Camden County Planning Board Agenda for January 28th, 2020

STAFF REPORT MEETING OF:	RE:	Hampton Rd. Redevelopment
	Plan:	SP-12-16-19
	Municipality:	Cherry Hill
	Applicant:	FMP CH Hampton. LLC
	Abuts County Route:	Cr. 636 Cuthbert Blvd & Cr. 623 Hampton Rd.

**CAMDEN COUNTY PLANNING BOARD
COUNTY ENGINEER'S REVIEW
OF SUBDIVISIONS AND
SITE DEVELOPMENT PLANS**

**COUNTY PLAN:
SP-12-16-19**

DETAILED SITE PLAN - WEST PORTION

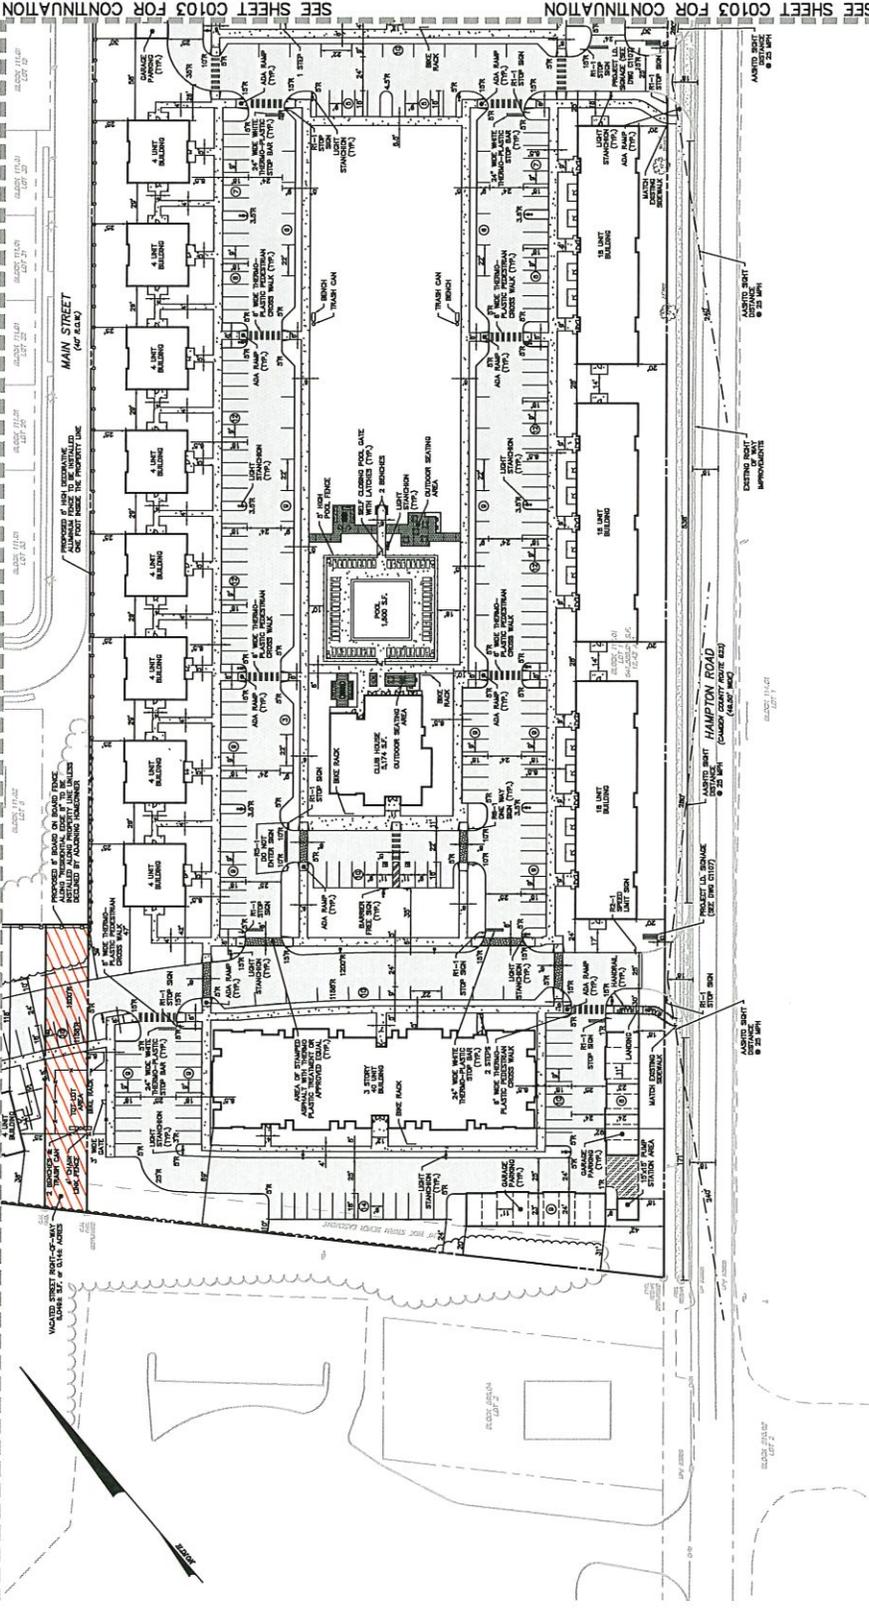
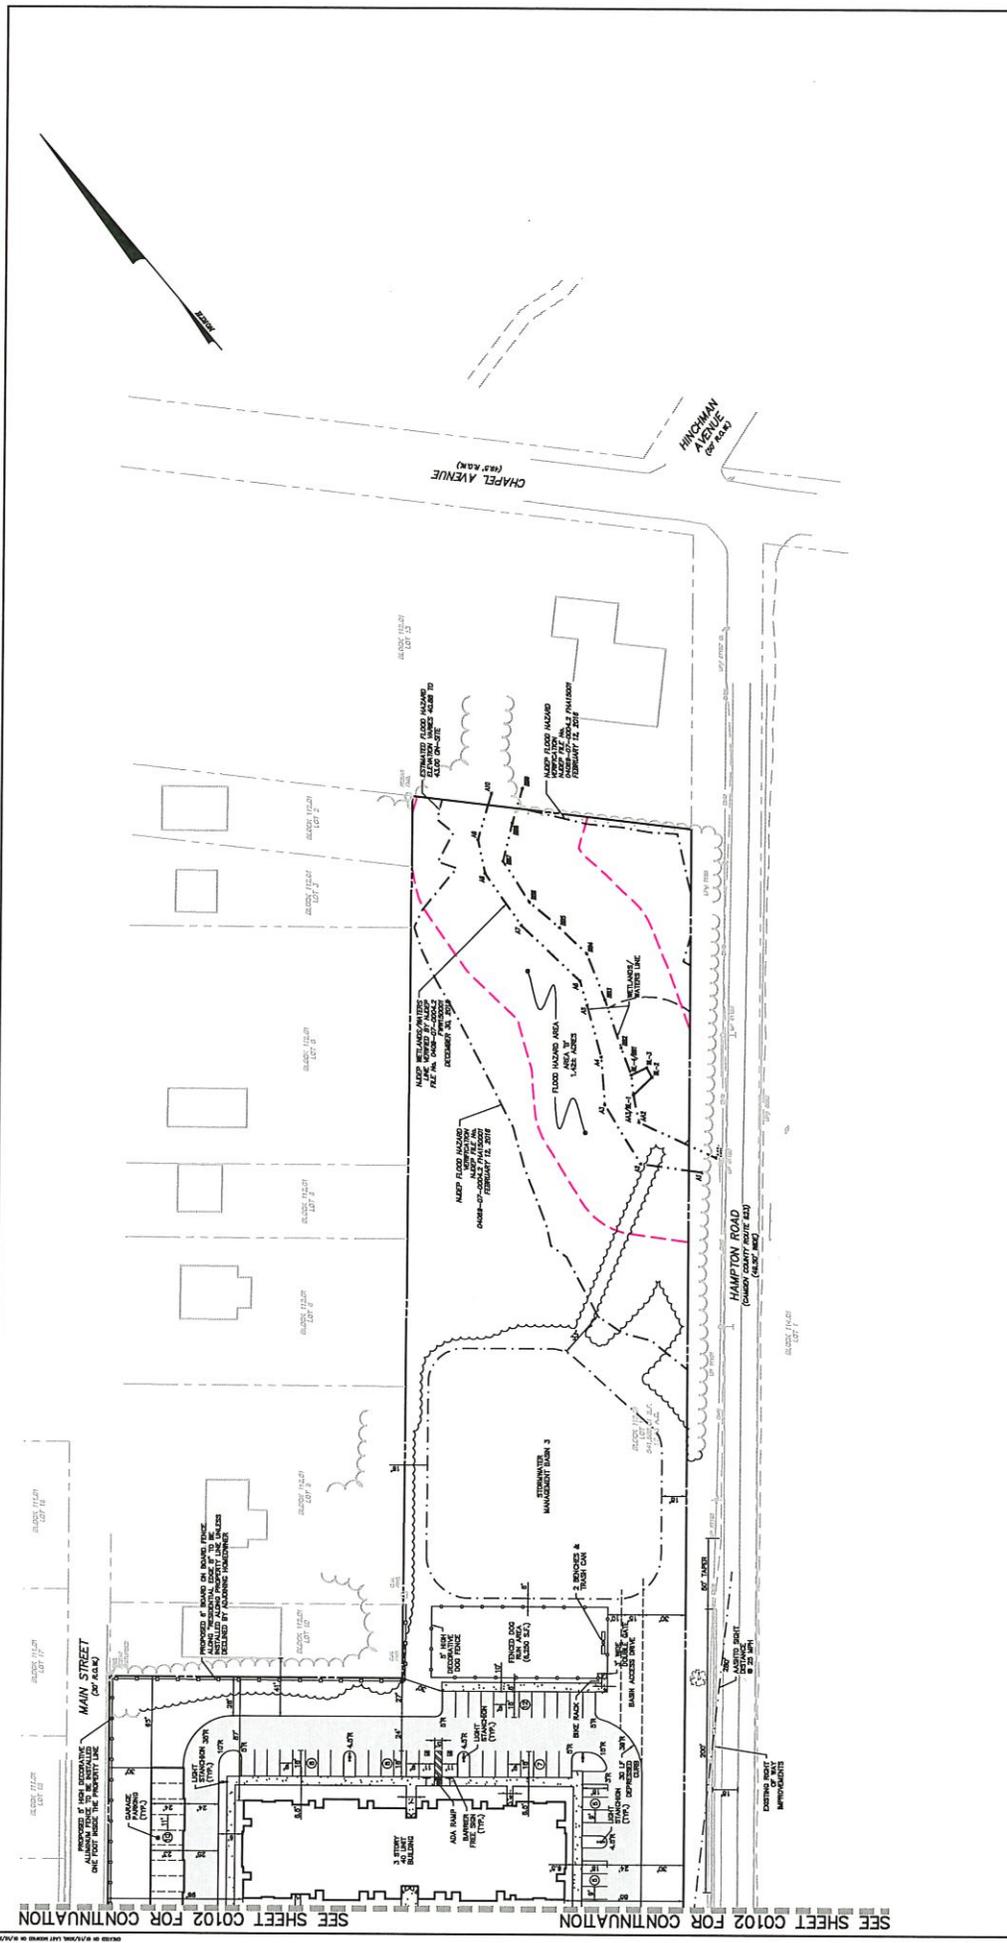
Please note that Cuthbert BLVD Cr. 636 changes to Magnolia Avenue Cr. 637 along the frontage of this property and herein is referred to as Magnolia Avenue Cr. 637 and all site plans sheets are required to reflect this change.

1. The site plans indicate only the limited replacement of curb along Magnolia Avenue (CR 637), to eliminate depressed curbs and construct the proposed site access. However, the curb is in poor condition and should be replaced along the entire site frontage.

2. The plans indicate a County pavement restoration detail for asphalt pavement. However, based on the sawed and sealed joints observed in the surface course, the Magnolia Avenue (CR 637) pavement includes a concrete base course. The base course must be sawcut 2' from the curb line and restored, monolithic with the curb. However, since an additional surface course joint within the existing bike lane is not acceptable, the surface course must be resurfaced to the nearest joint along the lane line, and the joint should be sawed and sealed. The appropriate restoration and the standard County concrete pavement detail must be indicated on the plans.

3. The Site Plan set should be revised to include plan sheets for improvements within the County right-of-way, including, but not limited to grading plans, sign and pavement marking plans, roadway profiles, cross sections and traffic control plans.

4. The gutter slope along Magnolia Avenue (CR 637) appears to be less than 0.5%. A roadway profile along the centerline and proposed gutter line should be provided. Monolithic curb and gutter (see County Standard Detail 2) is required if gutter slopes are less than 0.5%.

5. The Demolition Plan appears to indicate the removal of a utility pole that laterally braces another utility pole within the Magnolia Avenue (CR 637) right-of-way. Utility coordination and an alternate means of bracing the utility pole appear to be required to accommodate removal of this pole. The plans should be revised to clarify this work.

6. The plans should include a note indicating "All sidewalk and curb within the County right-of-way along the property frontage that is deteriorated or presents a tripping hazard shall be replaced under the direction of the County Engineer or his/her representative.

7. Sight triangles are shown on the site plans for each site driveway. Although the sight triangles shown on the plan use appropriate lengths based on AASHTO recommendations, the values are applied incorrectly. The sight distances for left turn movements are shown to the left of the driveways, and vice versa. However, AASHTO recommends the sight triangle values for right turn movements be applied to traffic approaching from the left and vice versa. The plans should be revised accordingly. Additionally, the applicant shall be required to submit a deed (or deeds) describing easements for each sight triangle and dedicating each easement to the County of Camden.

MAJOR SUBMISSION PLAN-SHEET B
 LAKESIDE
 PLATS 181.08, BLOCK 18301, LOTS 16, 17 & 18
 GLOUCESTER TOWNSHIP, CAUDEN COUNTY, NEW JERSEY

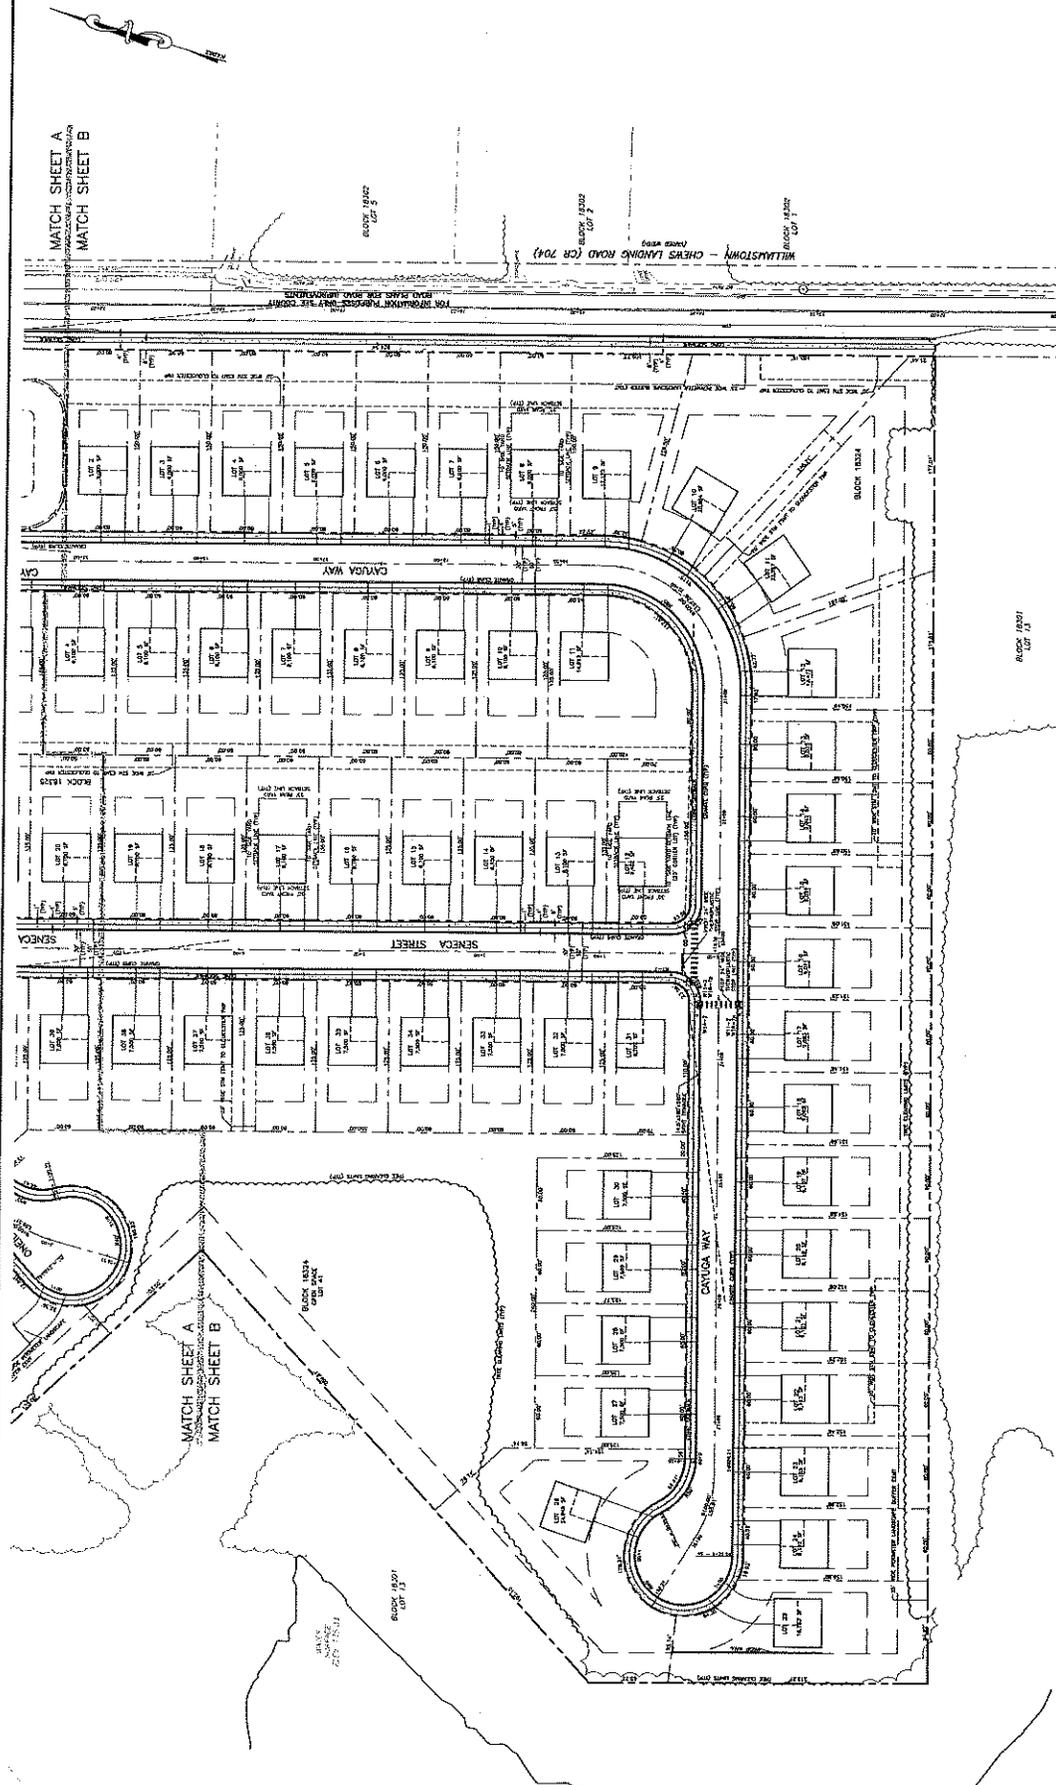
1. In accordance with 3.3.1.8, new roads shall be located to provide an unobstructed line of sight. Both the Site Plans and the Roadway Improvement Plans should be revised to show that the area within the Sight Triangle shall be free of all vegetation or obstructions 18" high or higher.

2. In accordance with County design standards, Chapter 3.2.1.1.G.4, the minimum curb radii where a new road or street intersects a county road shall be 35'. Currently 25' radii are proposed. The plans shall be revised accordingly.

3. The site plan should indicate the width of the stop bar for the Tahoe Street approach entering the county road. The width of the stop bar shall be in accordance with the current edition of the MUTCD, county design standards, and as more specifically directed by the County Engineer.

4. Sight triangle easements shall be required at the newly created intersection of Tahoe Road with the county road. Sight triangle easements should be in accordance with AASHTO standards and be shown on plans. The applicant shall be required to submit a deed of sight
